Title & Document Type: 8405A Vector Voltmeter Operating and Service Manual

Manual Part Number: 08405-90024

Revision Date: May 1971

VECTOR VOLTMETER 8405A

Figure 7-17(b), Schematic Diagram, Automatic Phase Control Section (Part 2) Sampling Pulse Generator (CHANGE 17)

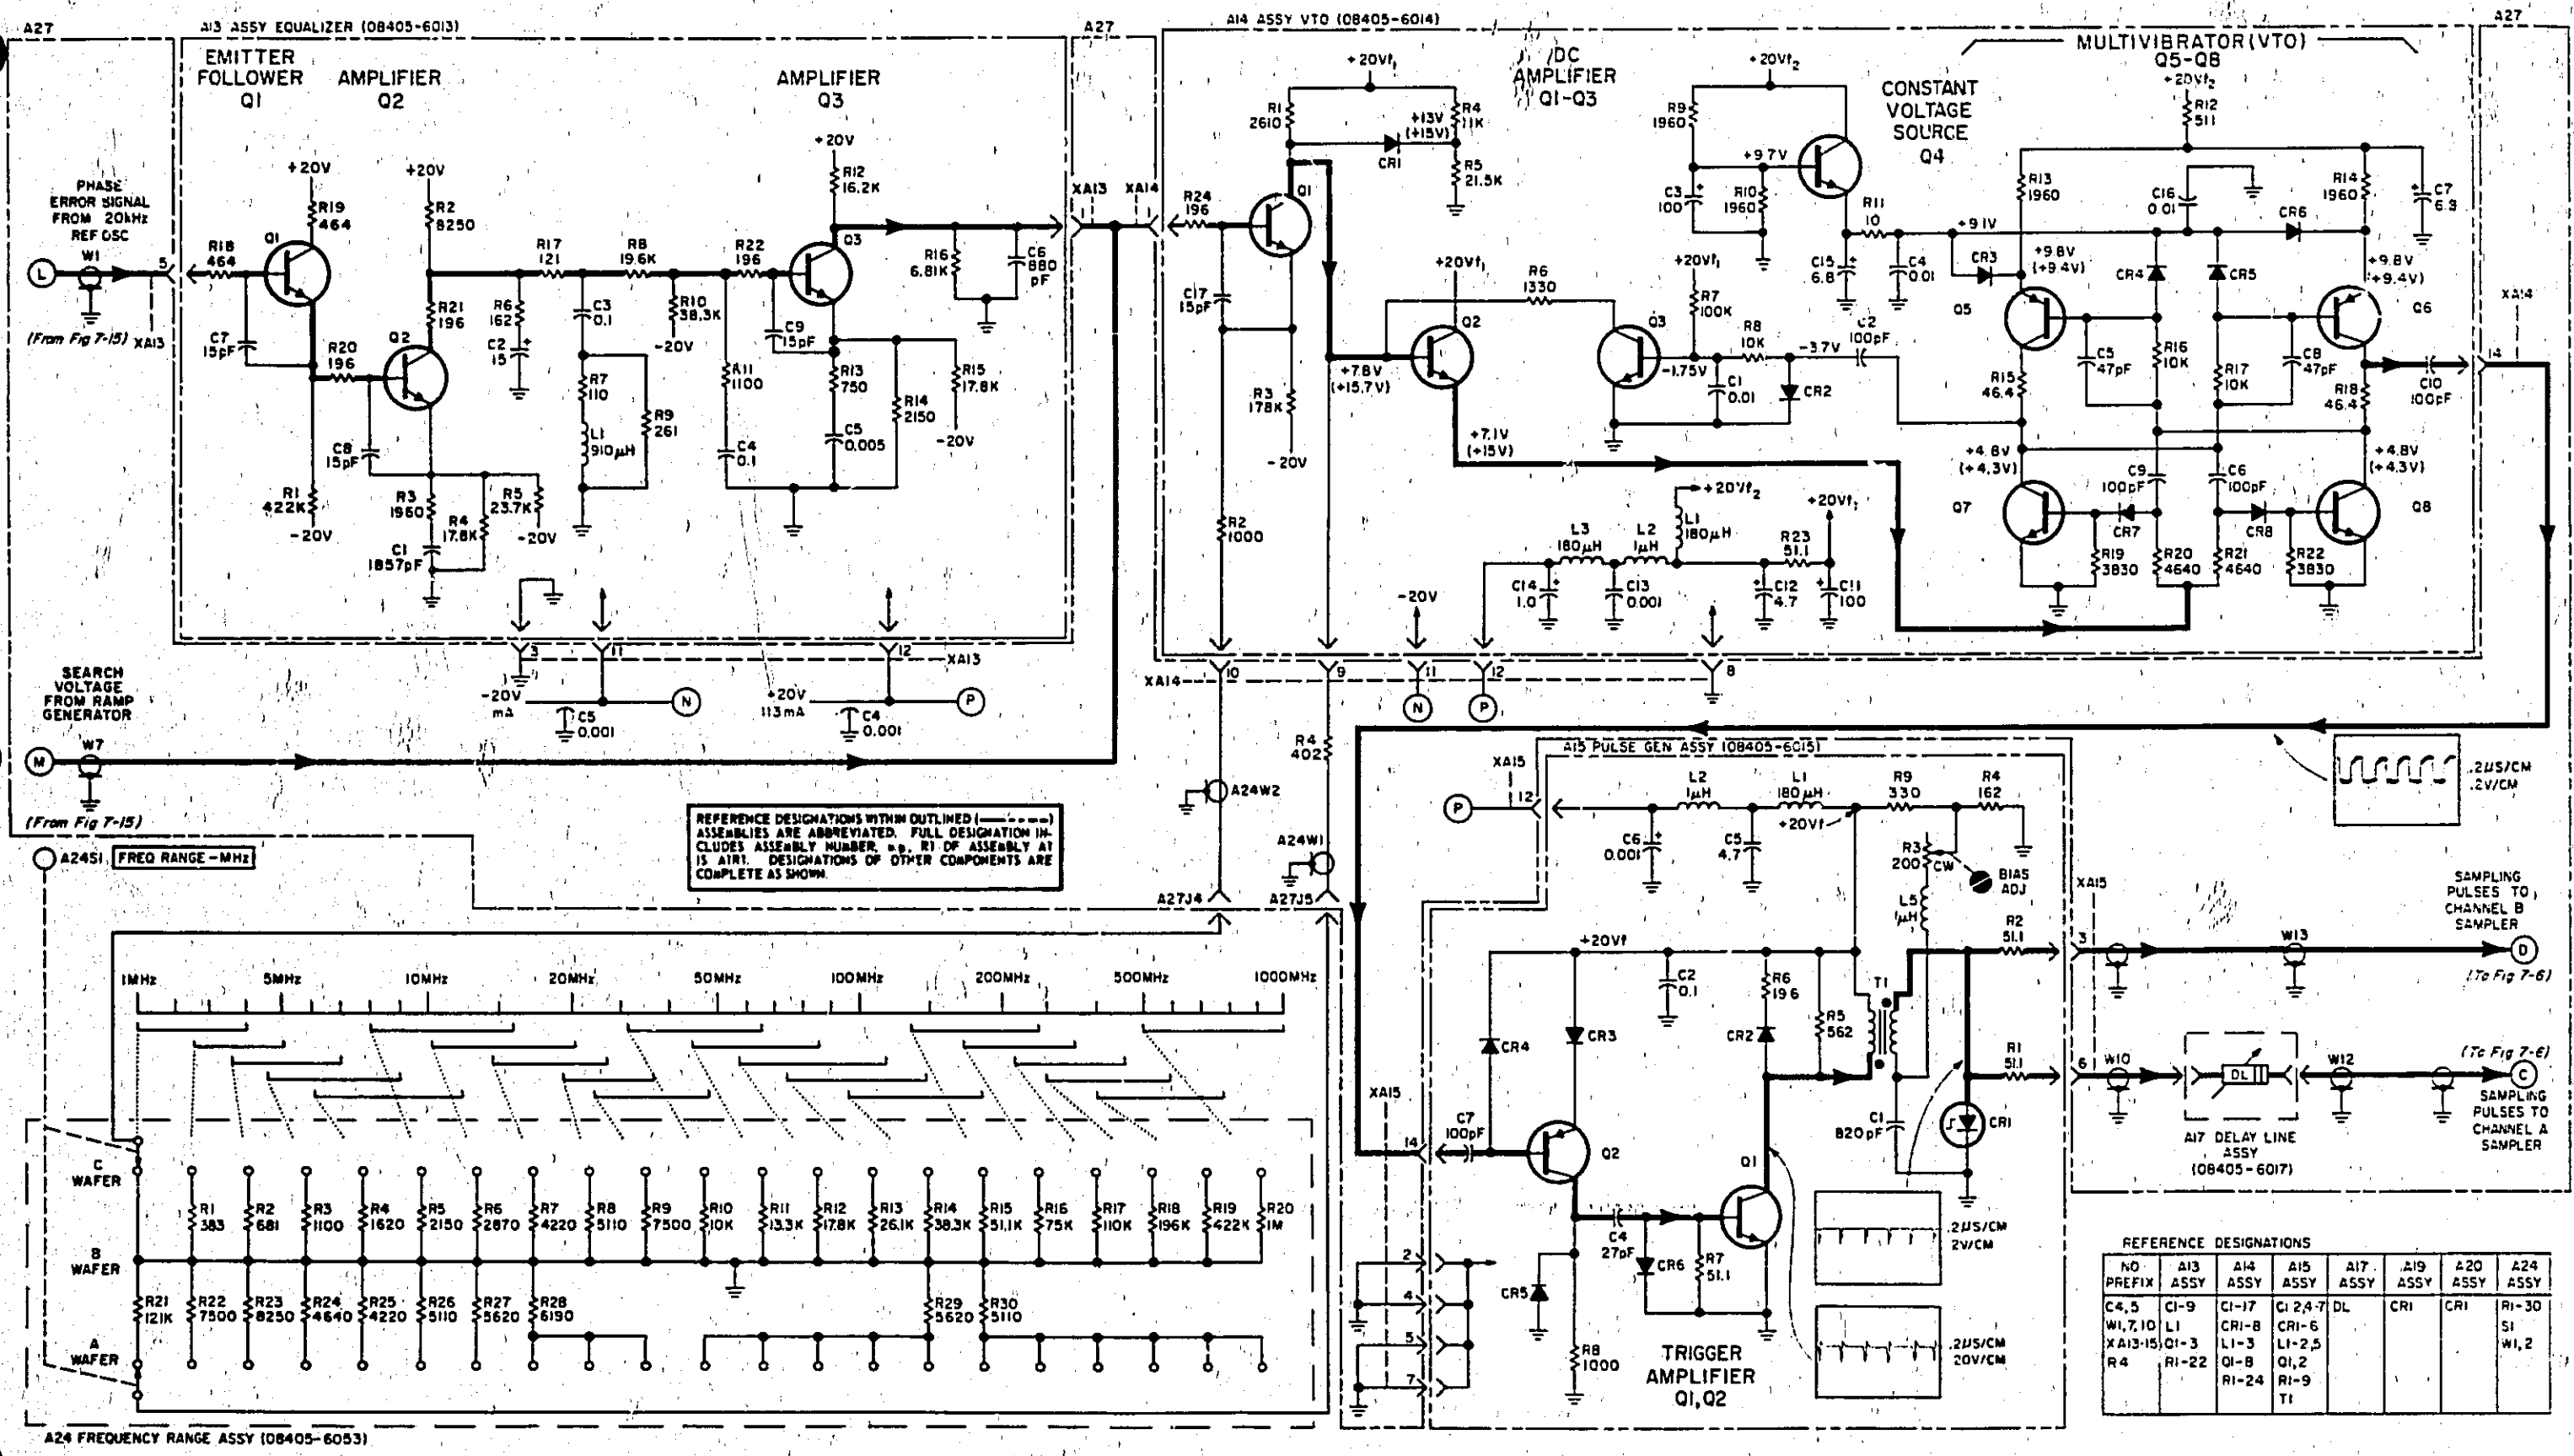
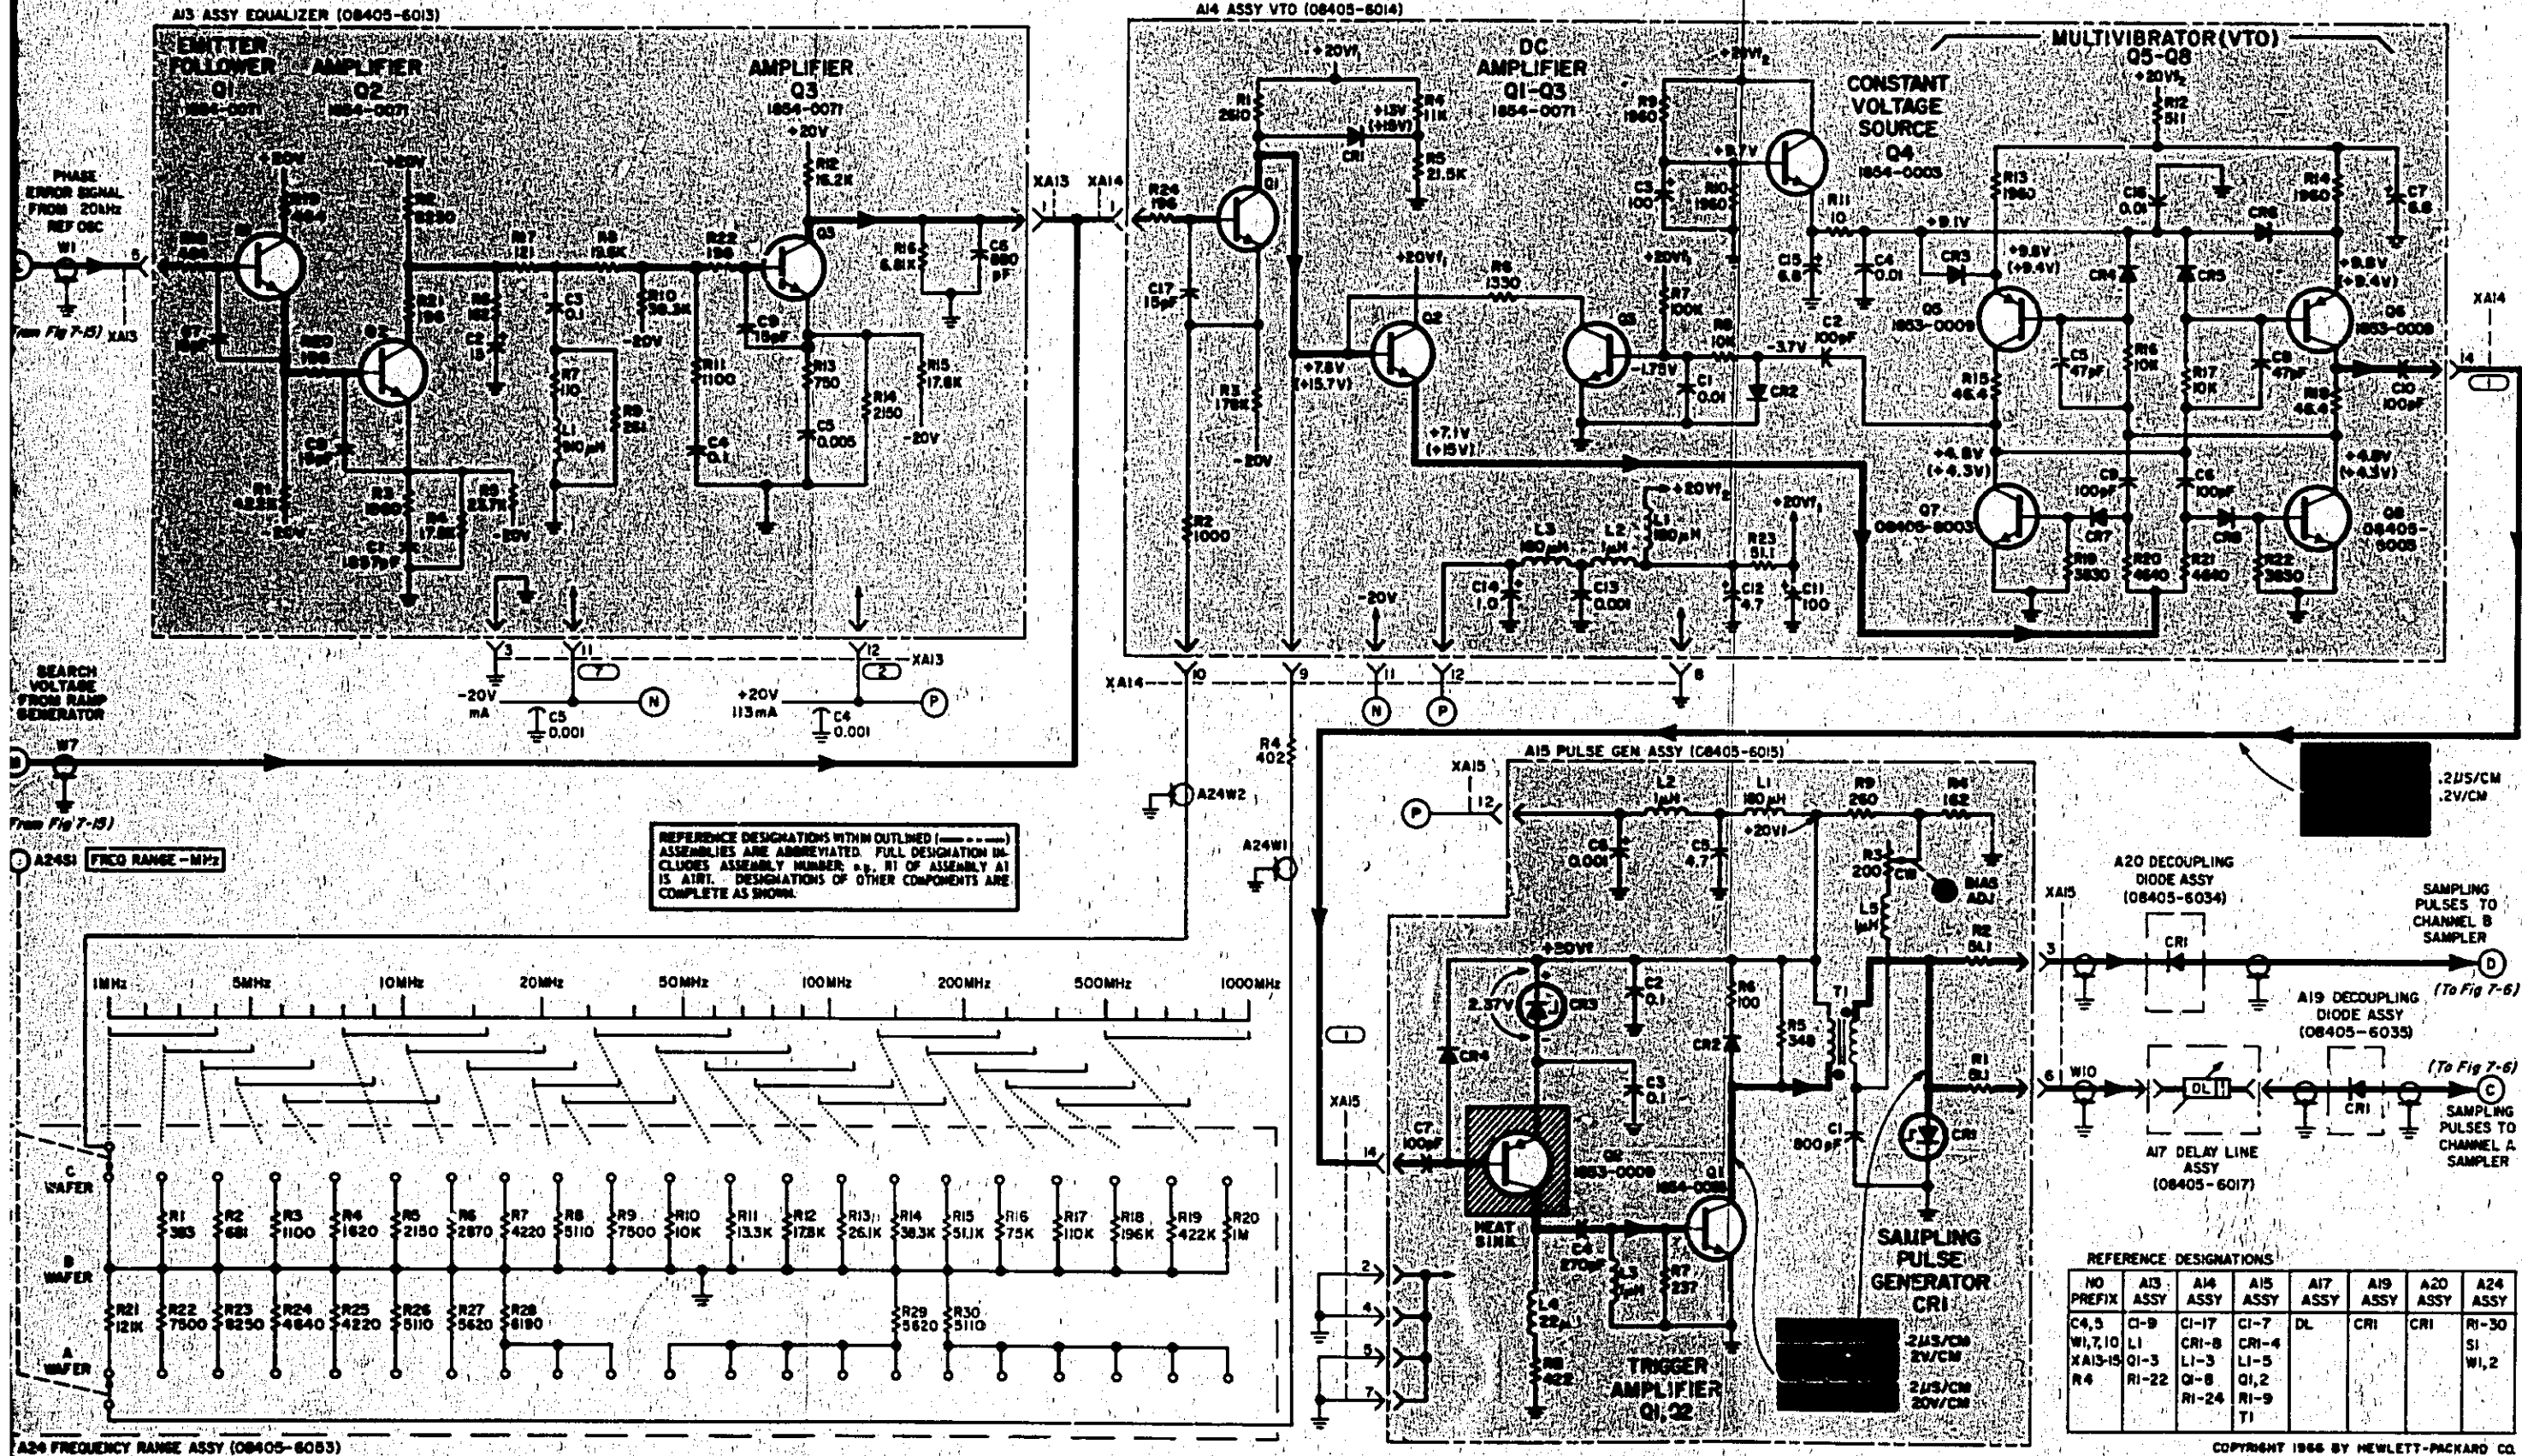
Figure 7-17(b):
Change A19 to 08405-60072.
Add A19CR2 in series with A19CRI, cathode toward A17.
Change A20 to 08405-60071.
Add A20CR2 in series with A20CRI, cathode toward XA15-3.

Figure 7-17(b):
Change A15R9 to 333 Ohms.

Figure 7-17(a):
Replace the part number 08405-6053 which identifies the A24 Frequency Range Assy with this note: See Table 6-1 for the current assembly number.
Figure 7-17(b) of Change 17:
Replace the part number 08405-6053 which identifies the A24 Frequency Range Assy with this note: See Table 6-1 for the current assembly number.
